ADDENDUM NO. 1

Date: March 28, 2018

Project: Earl Warren, John Bidwell and Tahoe ES Irrigation Improvements

SHEET NO.
L1.1A
SHEET 2 OF 35

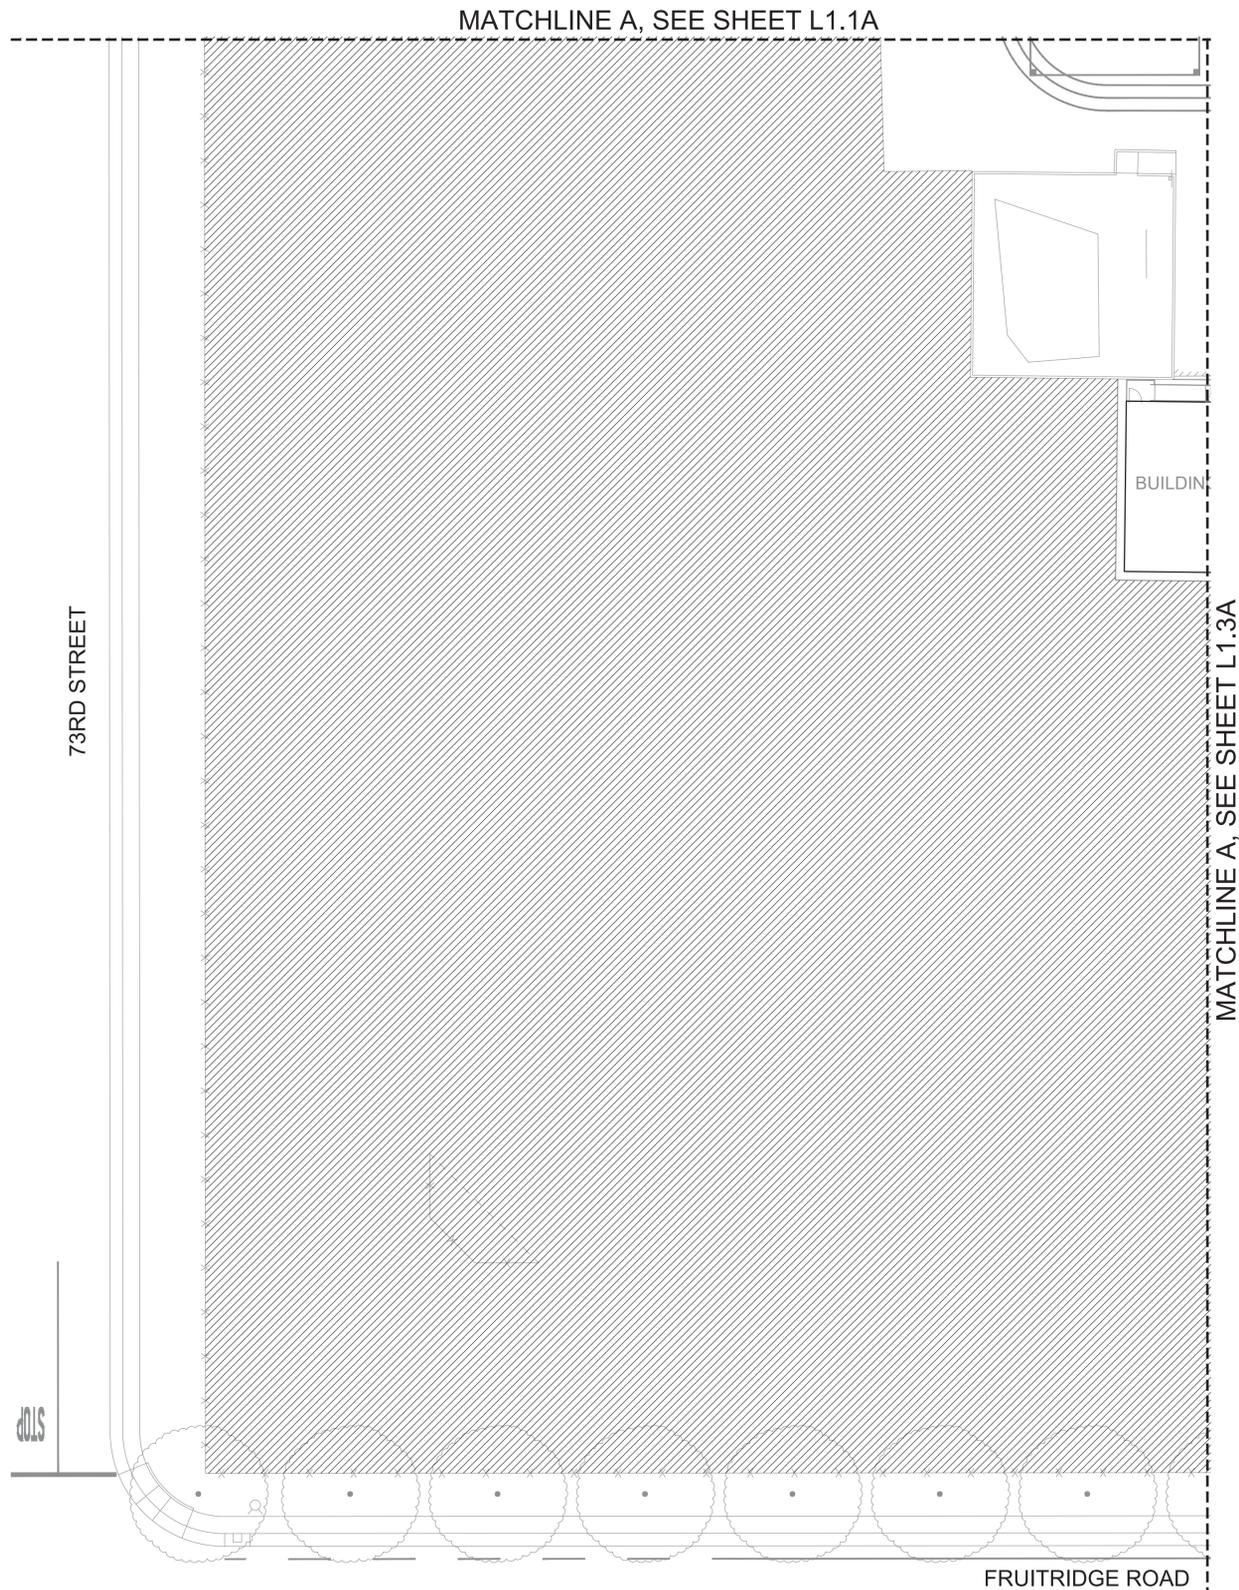
1. DRAWINGS – L1.1A, L1.2A, L1.3A
 - a. Note added to demo the existing irrigation pump and controller to the legend
 - b. Note revised to ‘place’ aggregate.

SHEET NO.
L1.4A
SHEET 5 OF 35

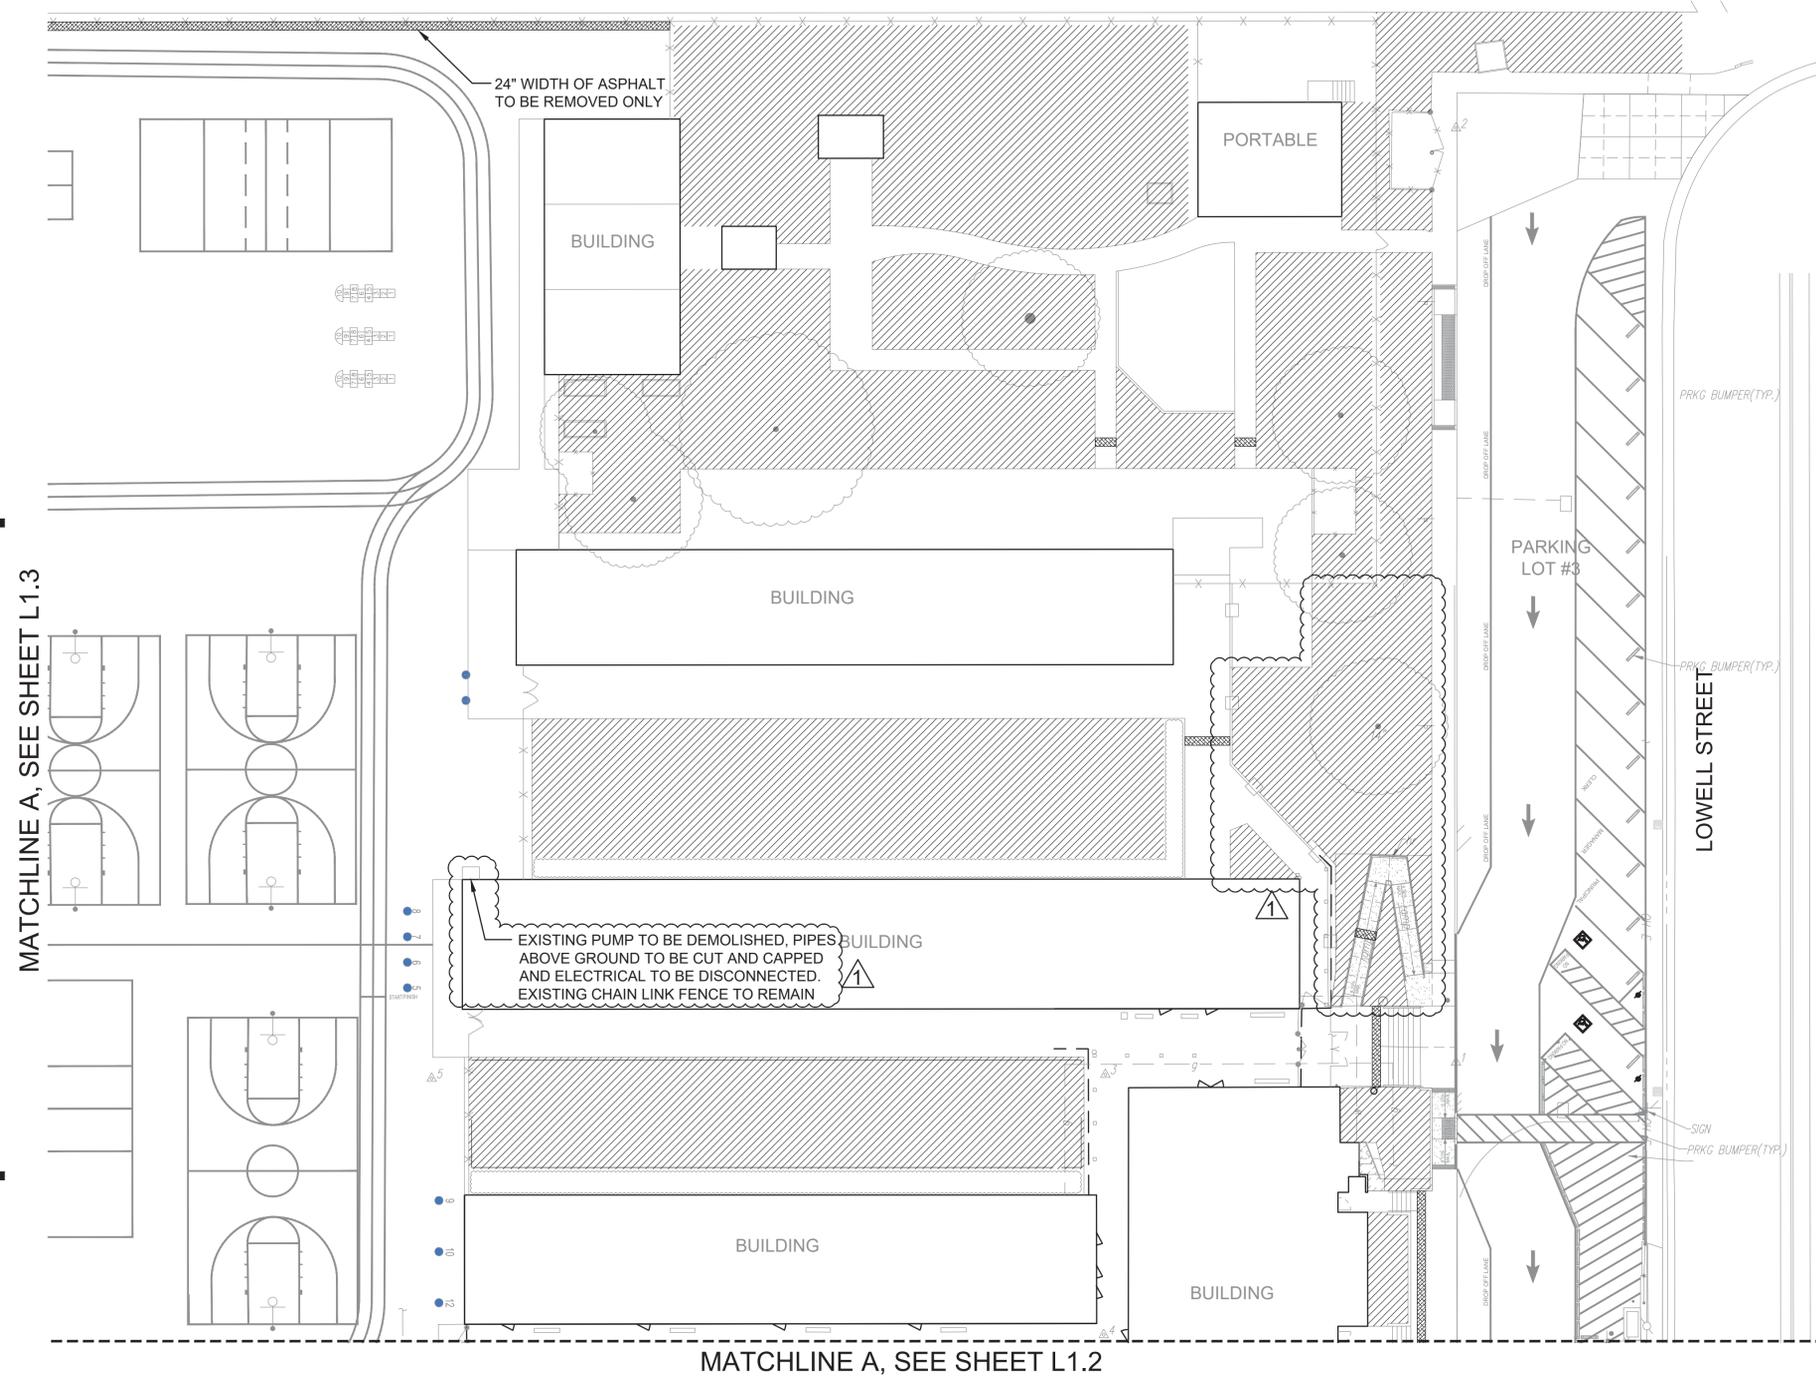
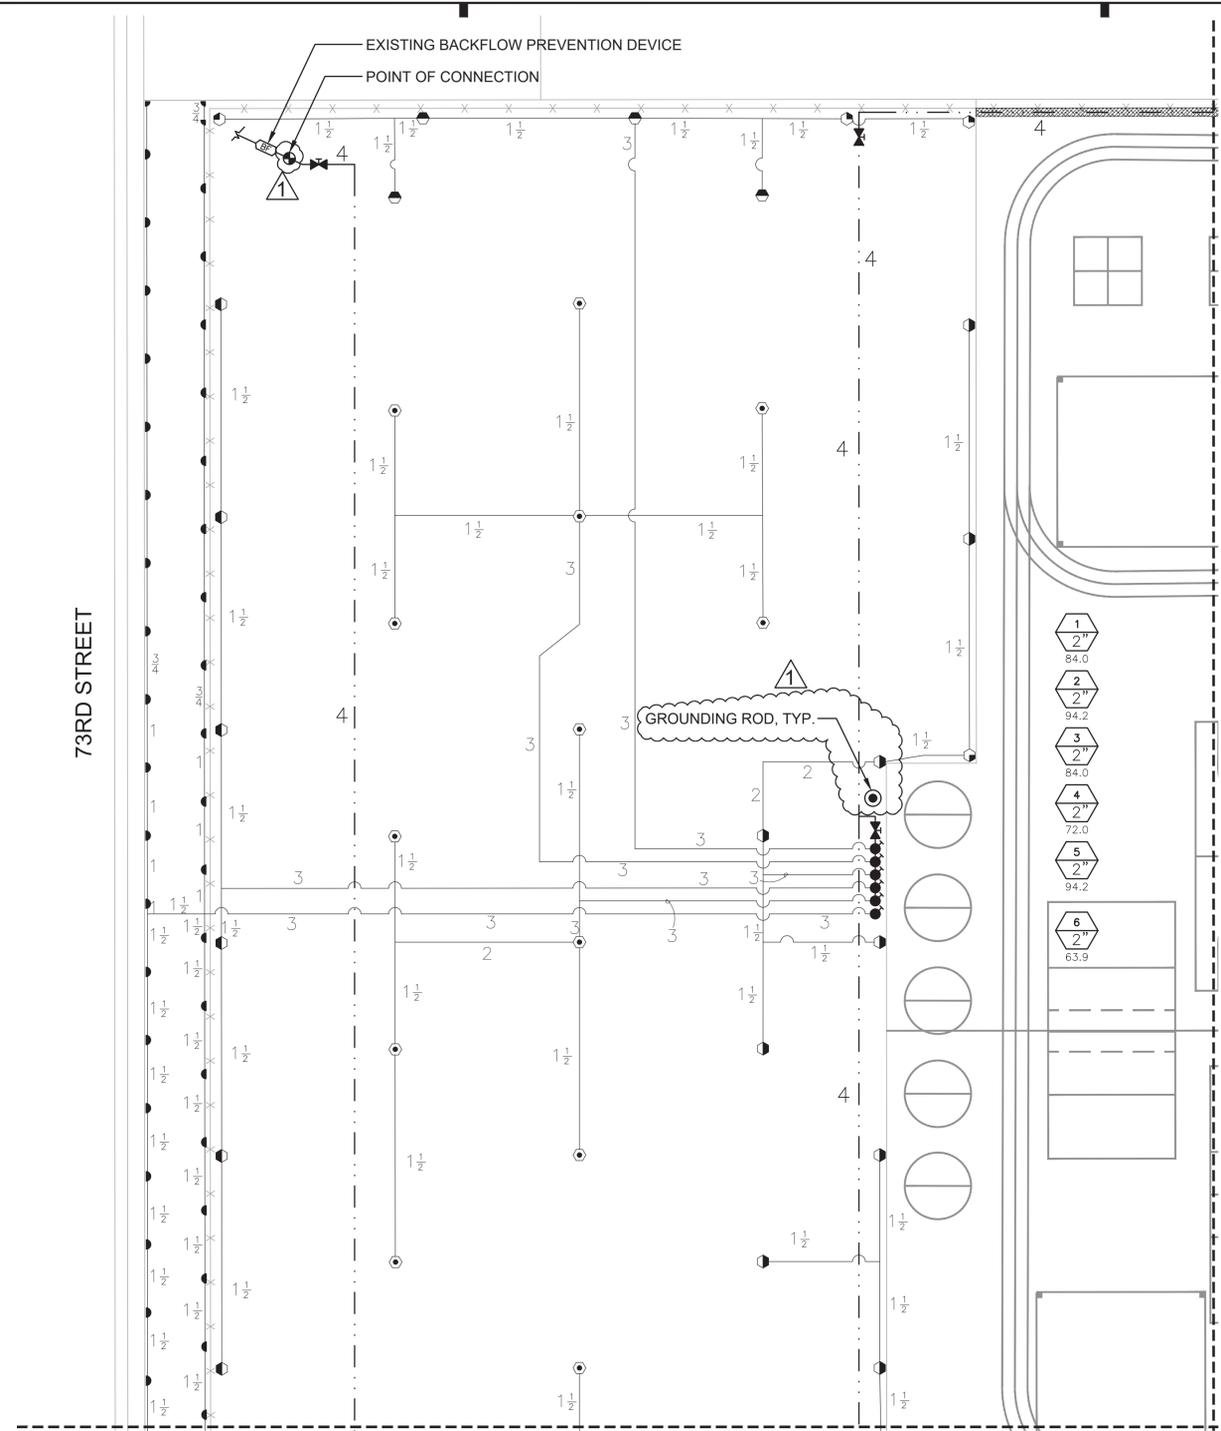
2. DRAWING – L1.4A
 - a. Note added to demo the existing irrigation pump and controller to the legend
 - b. Note revised to ‘place’ aggregate.
 - c. Added callout identifying location of existing irrigation pump and controller
 - d. Added irrigation area at front of campus that needs to have existing irrigation removed.

SHEET NO.
L2.2A
 SHEET 7 OF 35

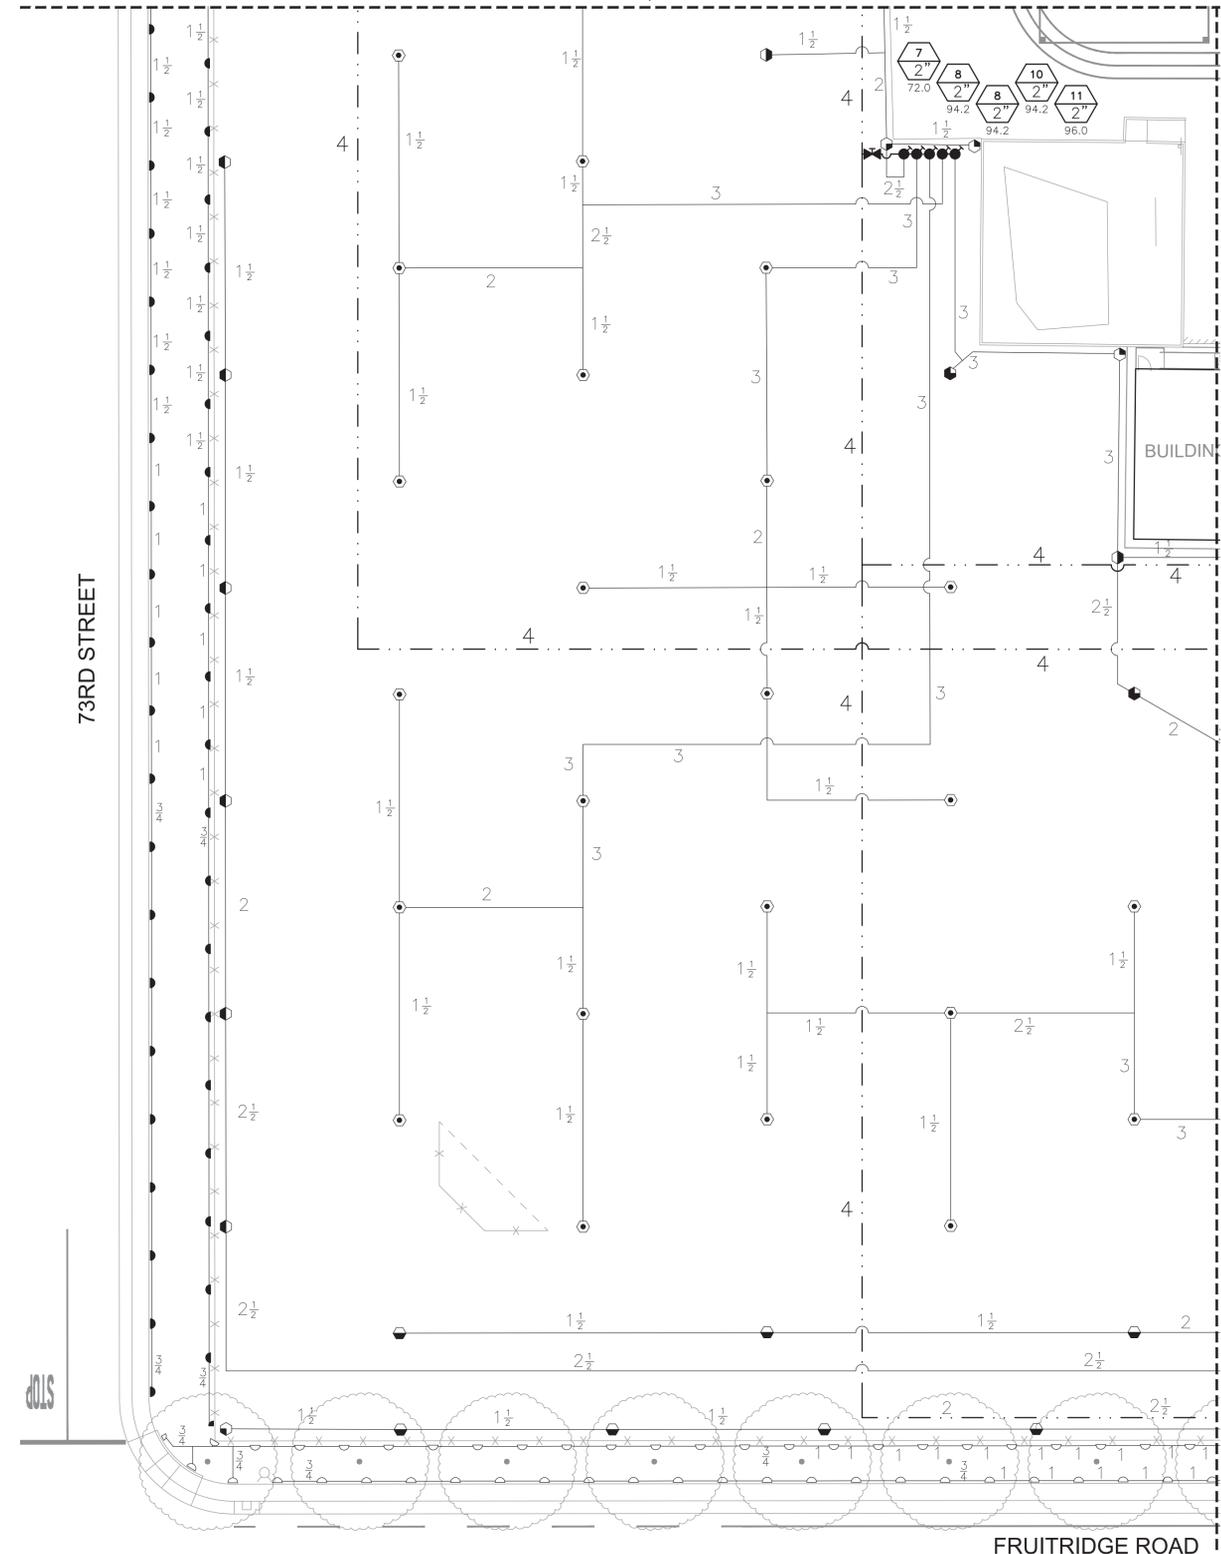
4. DRAWING – L2.2A
 - a. Revised sheet number from ‘4’ to ‘7’

- b. Revised master valve model number.
 - c. Revised irrigation mainline pipe material in legend.
 - d. Added note to 1” steel conduit for two-wire cable in legend.

- e. Added grounding rod assembly symbol to legend.
5. DRAWING – L2.3A
- a. Revised master valve model number.
 - b. Revised irrigation mainline pipe material in legend.

DATE	2/15/18
JOB NO.	17-68
SHEET TITLE	
EARL WARREN ES LANDSCAPE IRRIGATION PLAN	
SHEET NO.	
L2.3A	
SHEET 8 OF 35

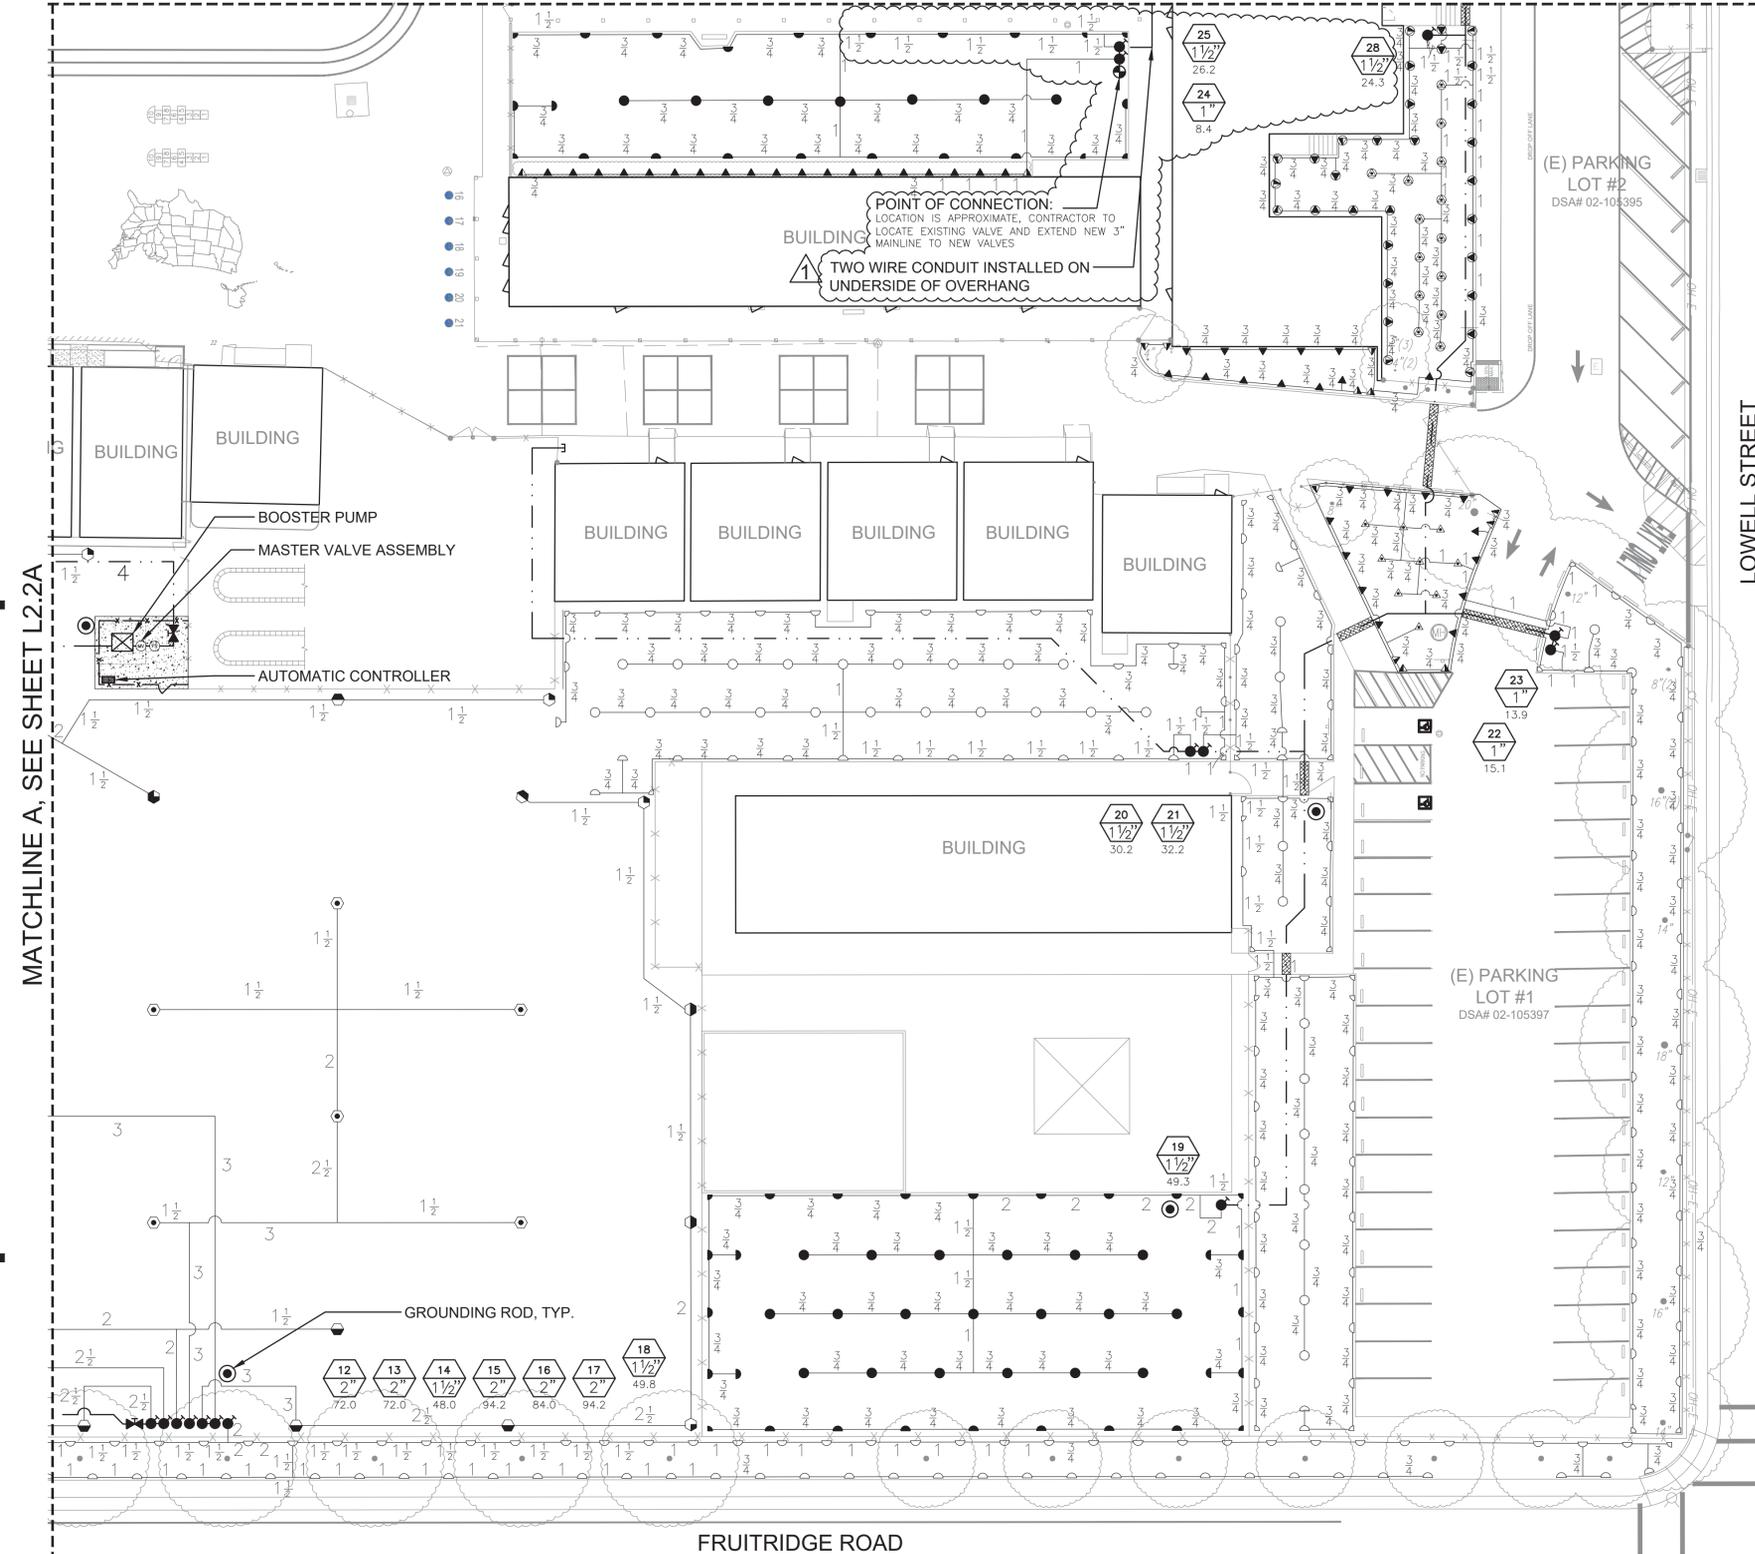
- c. Added note to 1” steel conduit for two-wire cable in legend.
 - d. Added grounding rod assembly symbol to legend.
 - e. Added pipe size to lateral lines connected to valve #25, and added a point of connection for valves #24-25, and renumbered valves #24, 25, 28.
